SERVICE BULLETIN

APPLICABILITY: 2012-2016MY Impreza
 2013-2017MY Crosstrek
 2014-2018MY Forester

NUMBER: 04-21-18

SUBJECT: Uneven Steering Effort

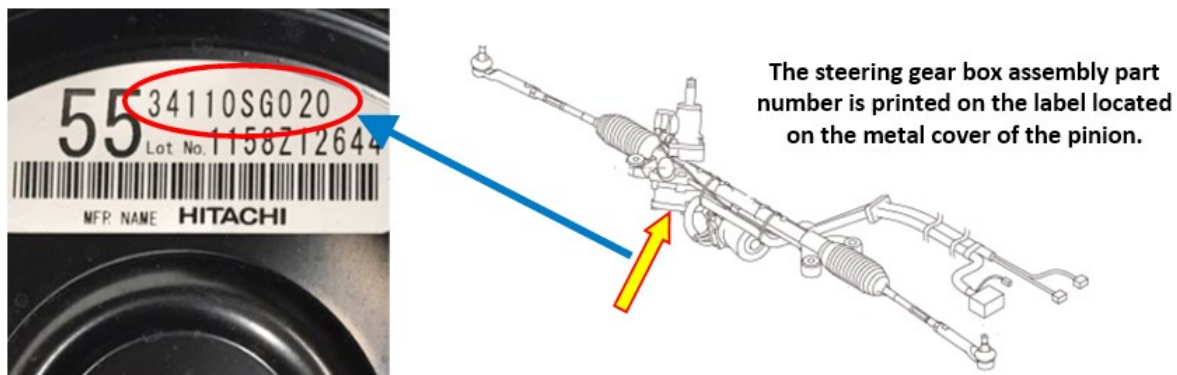
If a vehicle is presented with a customer concern of uneven steering wheel effort felt when turning, after confirming the condition, inspect the steering gear box in the circled area shown in the illustration for any evidence of cracking.

To determine if the steering gear box is a new-style unit, verify and compare the part number on the label located on the bottom cover of the pinion as shown below to the Part Information table on pg. 1. The new assemblies have been re-designed in addition to utilizing materials having improved rust and corrosion resistance.

If a crack is confirmed, the EPS steering gear box assembly must be replaced. The service procedures for replacing the assembly remain unchanged. Always refer to the applicable Service Manual and review the full requirements of the repair being performed. The Service Manual procedures contain information critical to performing an effective repair the first time and every time. This includes but is not limited to: important SAFETY precautions, proper inspection criteria, necessary special tools, required processes and related one-time-use parts needed for a complete and lasting repair.
